CAPITAL PLAZA ROOF REPLACEMENT PHASE 2 COMMONWEALTH OF KENTUCKY FRANKFORT, KENTUCKY

FINANCE + ADMINISTRATION CABINET
DEPARTMENT FOR FACILITIES MANAGEMENT
DIVISION OF ENGINEERING
ENGINEERING FILE NO. M- 219-43
ACCOUNT NO. 02-39-785-2002

RECORD DRAWINGS
These record drawings reflect approved changes made during construction. Date 7-15-97

PARTIAL ROOF PLAN (SECTOR B-1)

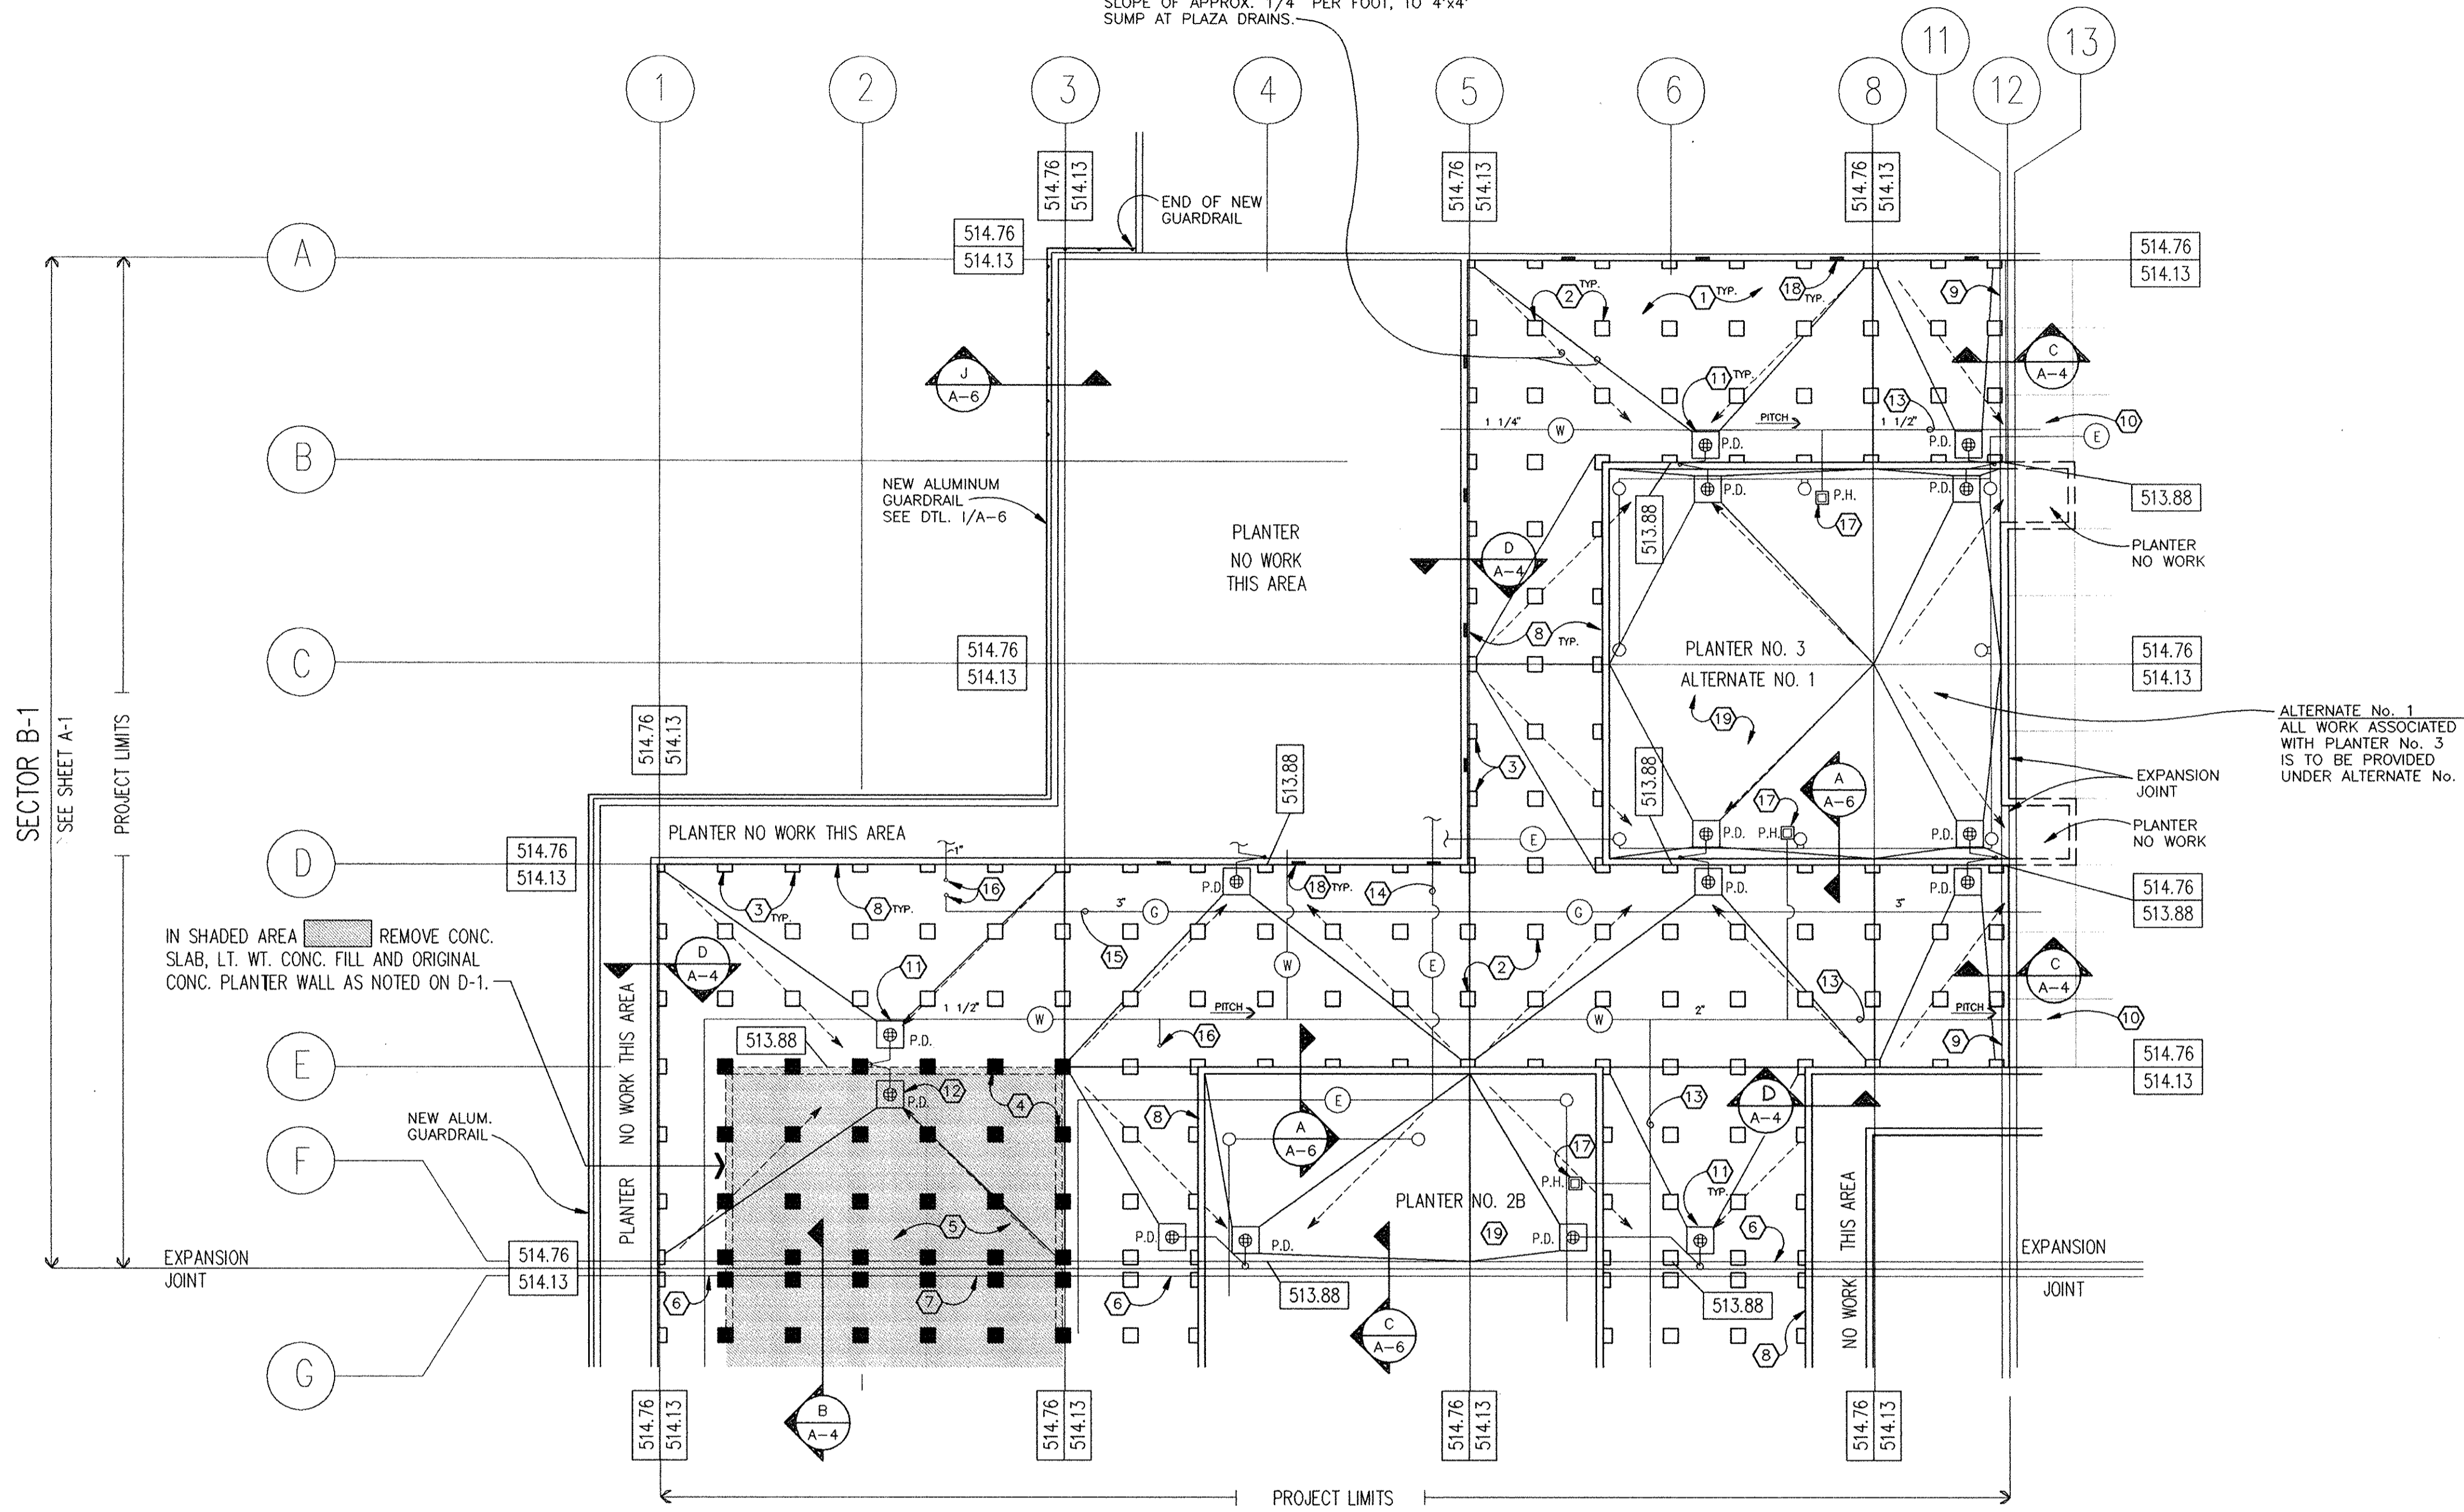
- 18 REFURBISH EXISTING LIGHT FIXTURE w/ REFLECTOR, BULB, LENSE AND PROTECTIVE FACE/GRILL AS REQUIRED. SEE DETAIL F/A-6. **CHANGE ORDER #3**
- 19 INSTALL NEW TREES (2 1/2" MIN. CALIPER) AND SHRUBS (2 GAL. MIN) TO MATCH EXISTING. PROVIDE SOD FOR ENTIRE PLANTER AREA.

PARTIAL ROOF PLAN (SECTOR B-2)

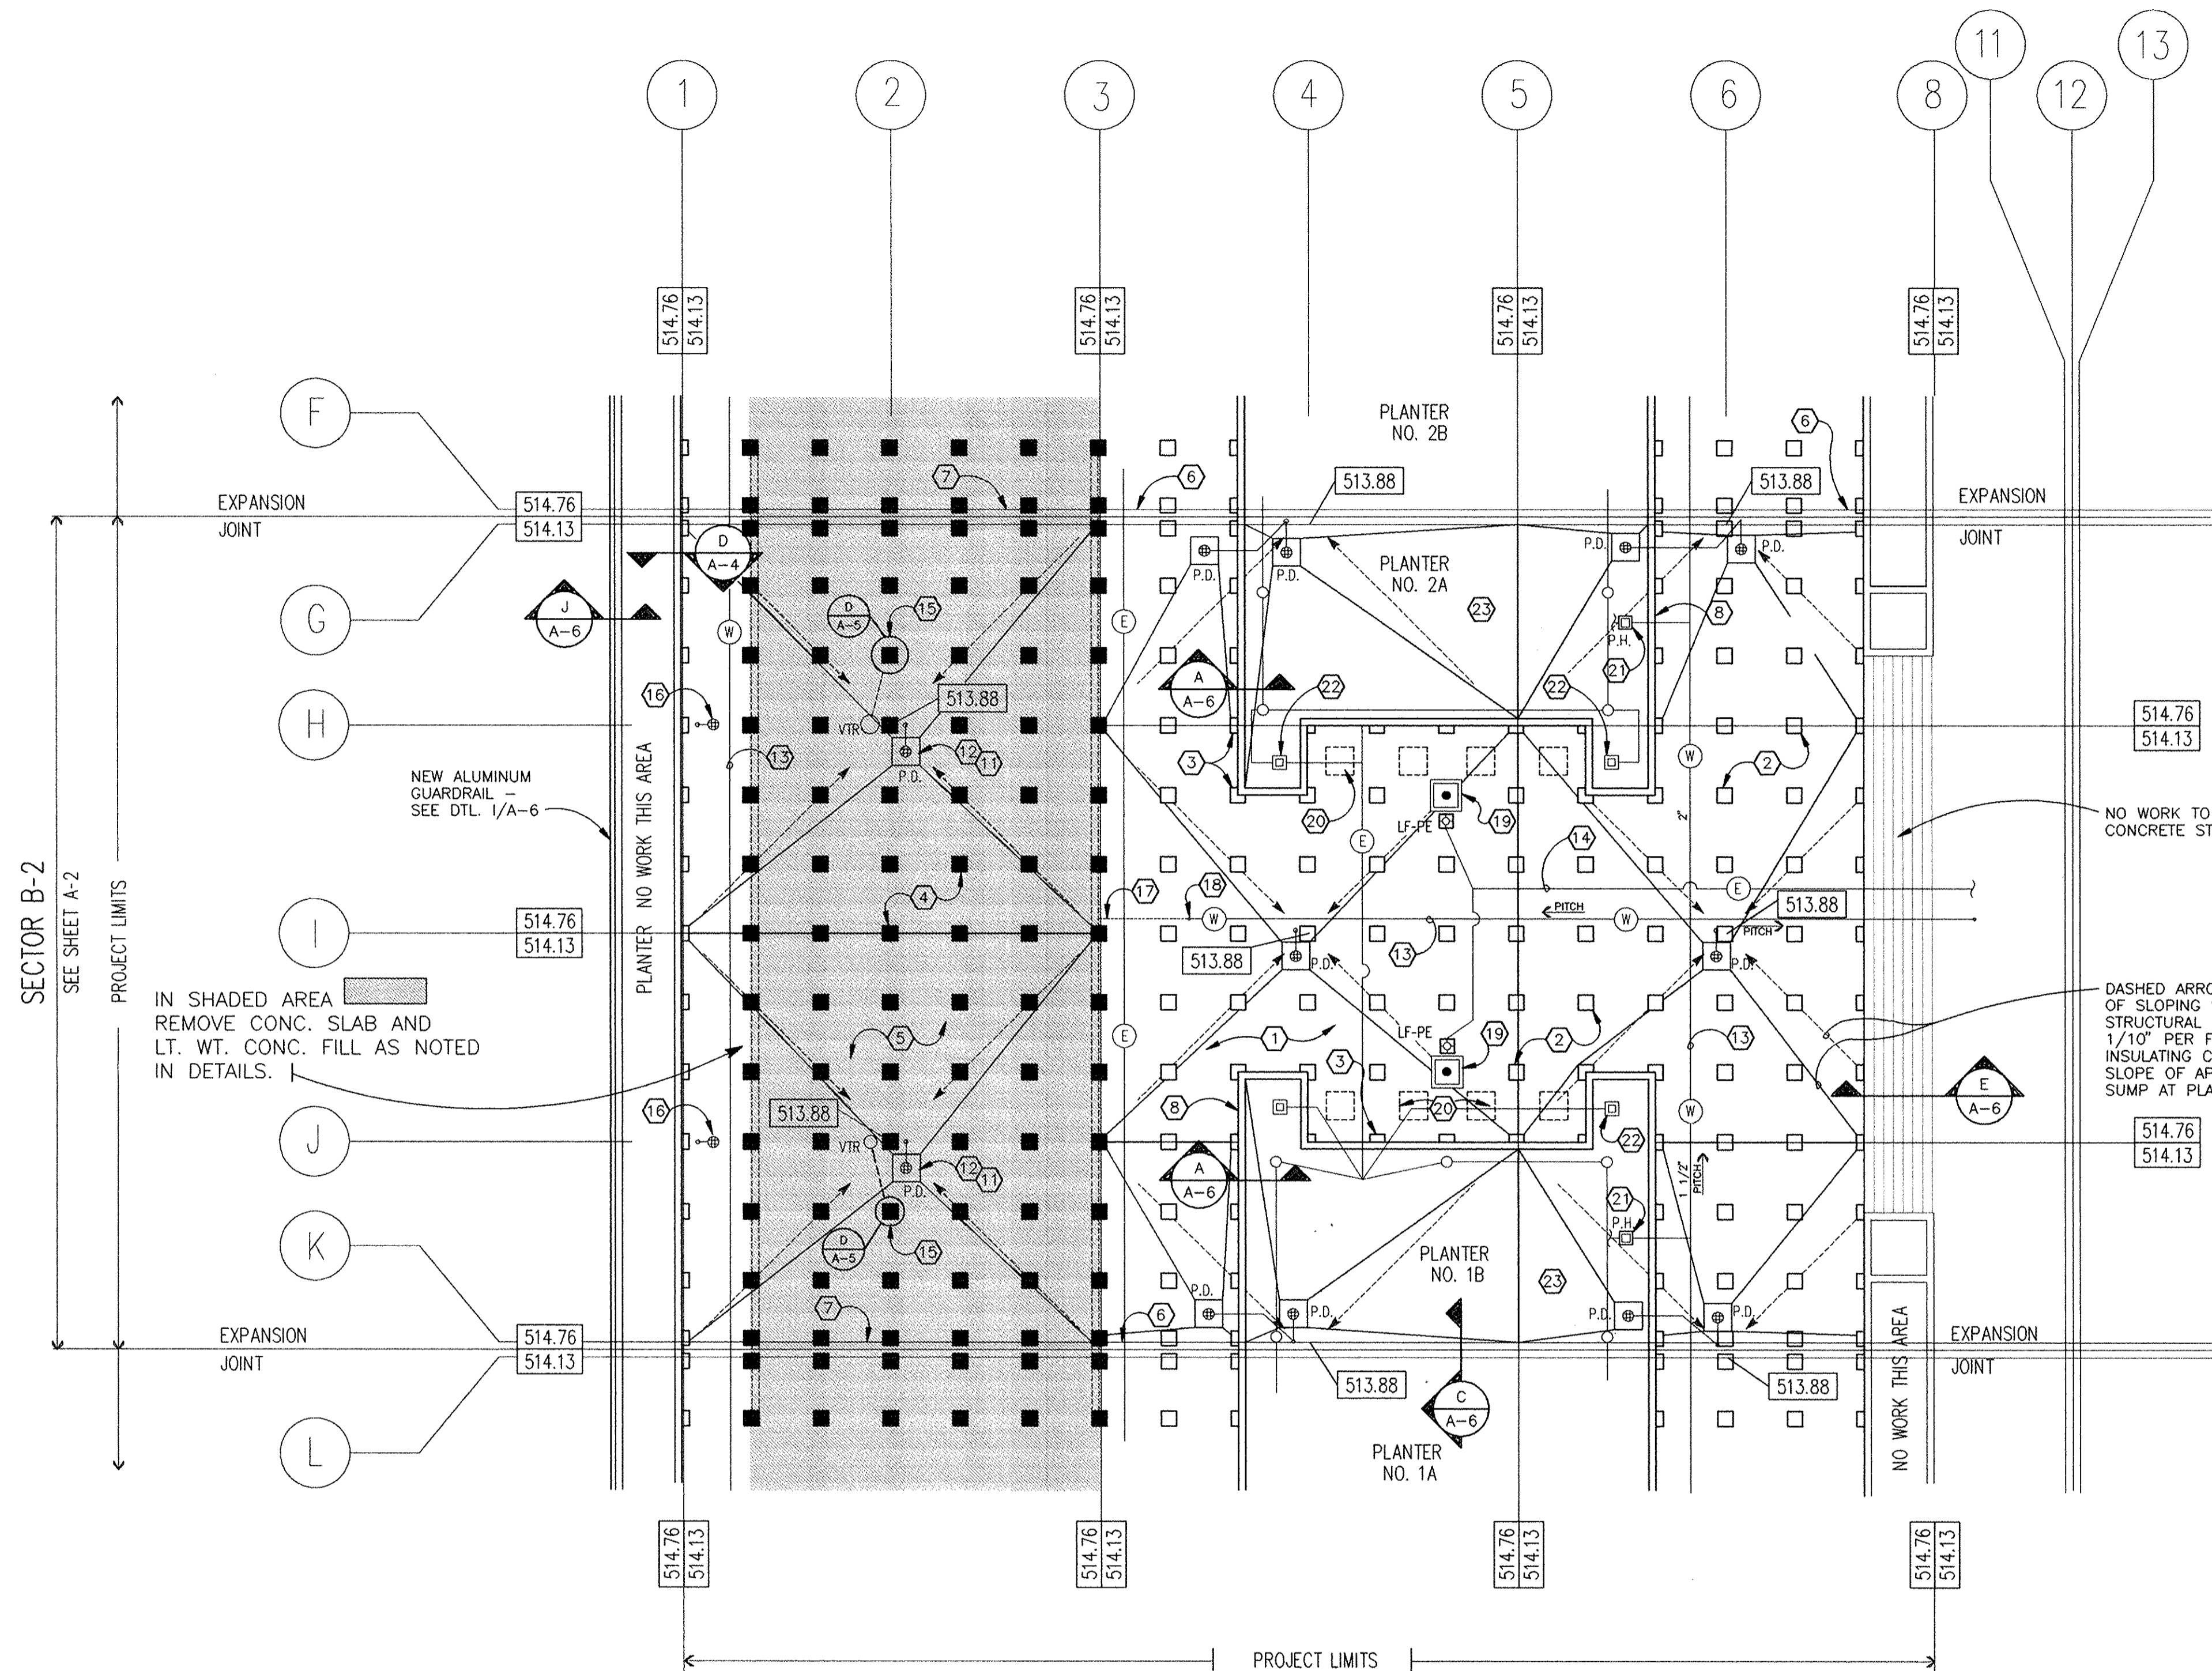
- 22 EXISTING LIGHT POLE BASE TO RECEIVE NEW S.S. CAP PER DTL. D/A-6. C.O.#4
- 23 INSTALL NEW TREES (2-1/2" MIN CALIPER) AND SHRUBS (2 GAL MIN) TO MATCH EXISTING PROVIDE SOD FOR ENTIRE PLANTER AREA

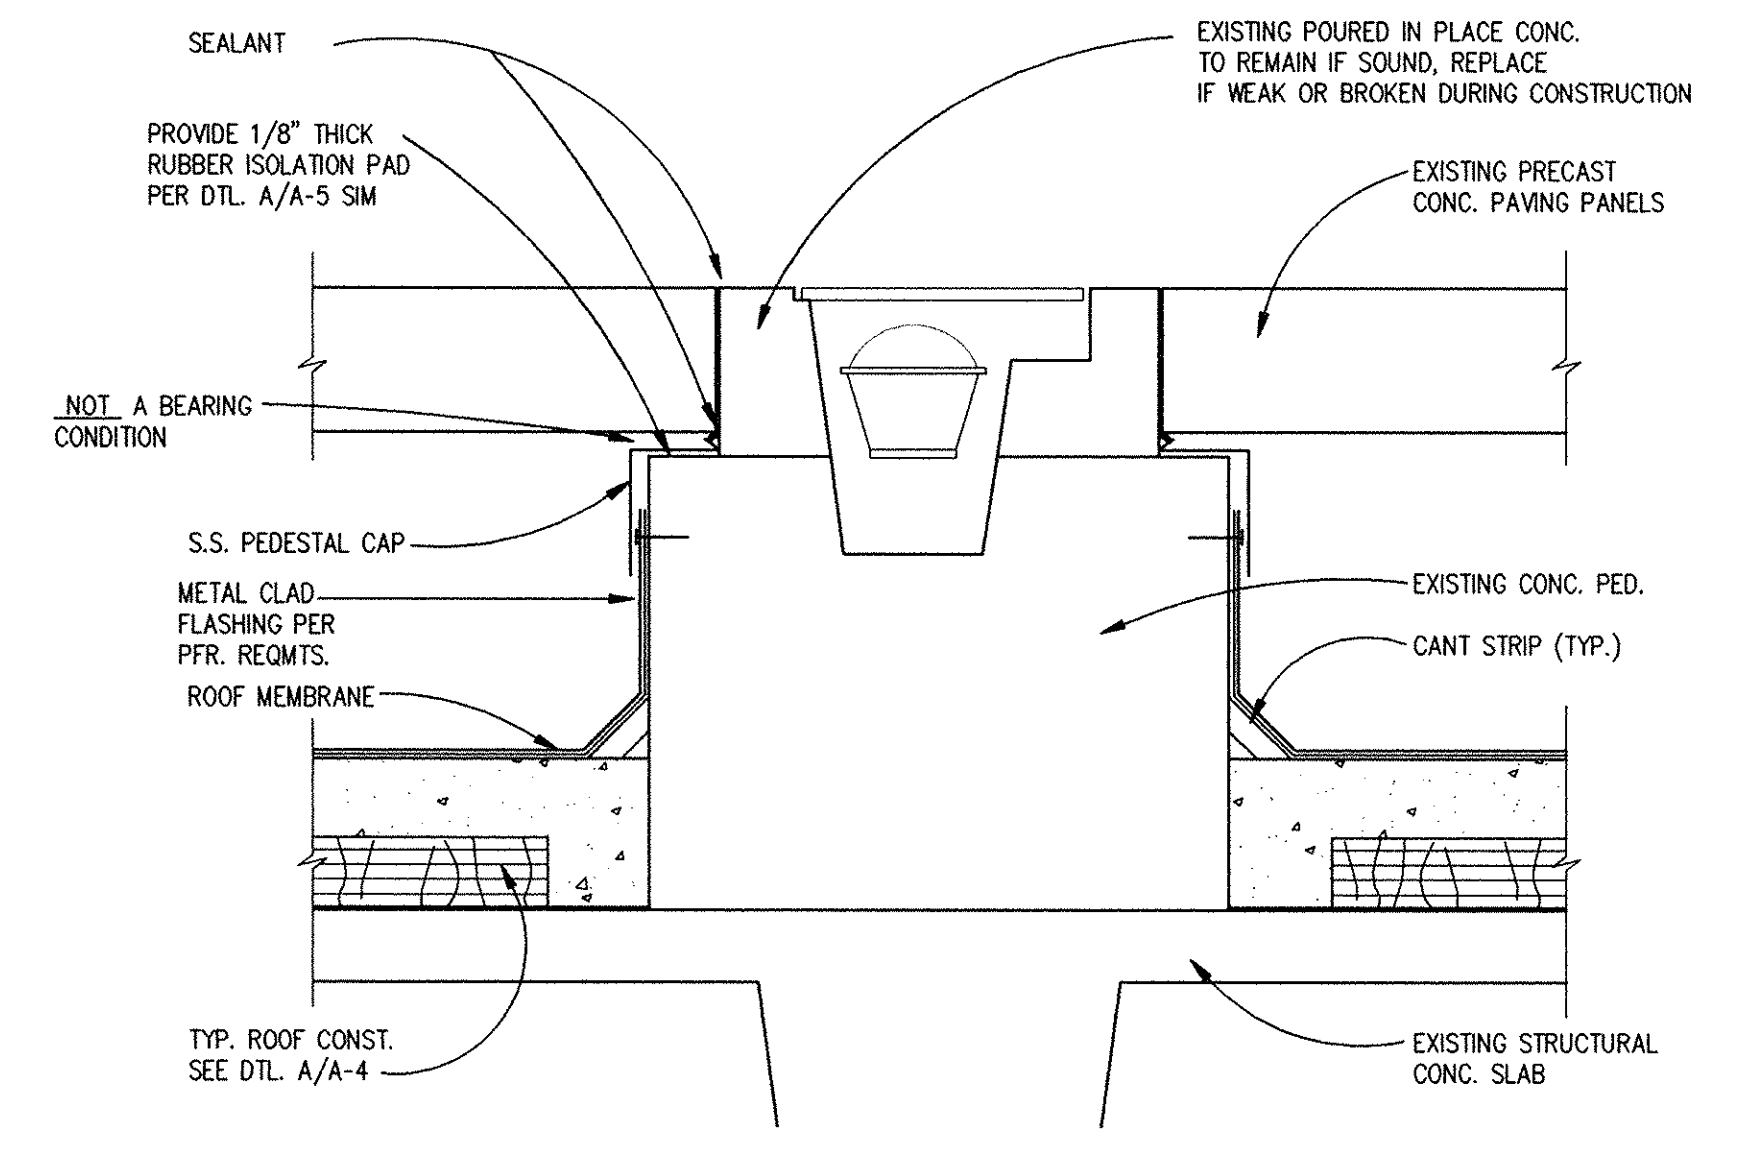
CHANGE ORDER #2
Perimeter reglet as indicated on original construction drawings of Capital Plaza was not installed in this area. Provide aluminum termination bar anchored to concrete wall and sealed along top edge as required by roofing manufacturer. Warranty as specified to include this termination method.

PERIMETER TERMINATION @ STAIRS E
 SCALE: 1 1/2" = 1'-0" A-6

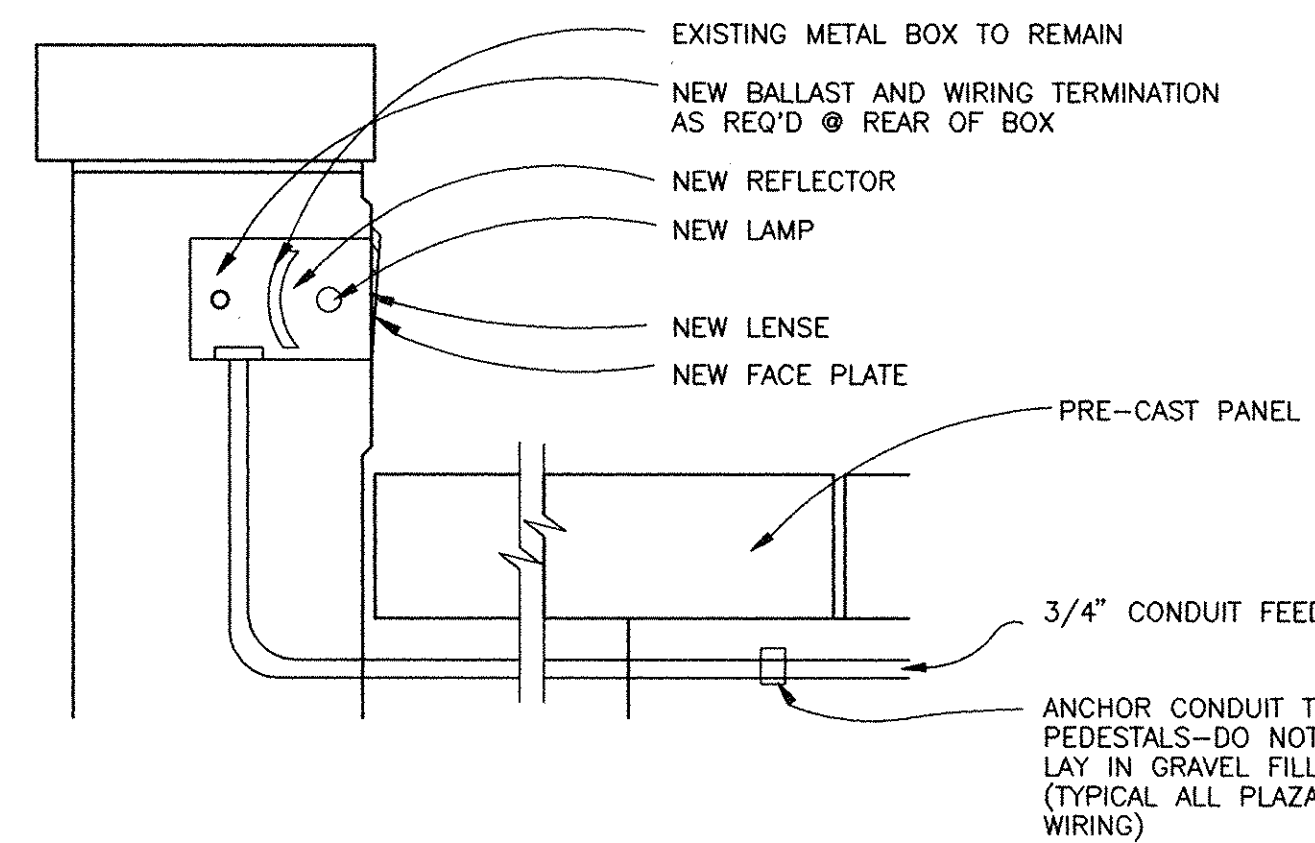
CHANGE ORDER #2
 Perimeter reglet as indicated on original construction drawings of Capital Plaza was not installed in this area. Provide aluminum termination bar anchored to concrete wall and sealed along top edge as required by roofing manufacturer. Warranty as specified to include this termination method.
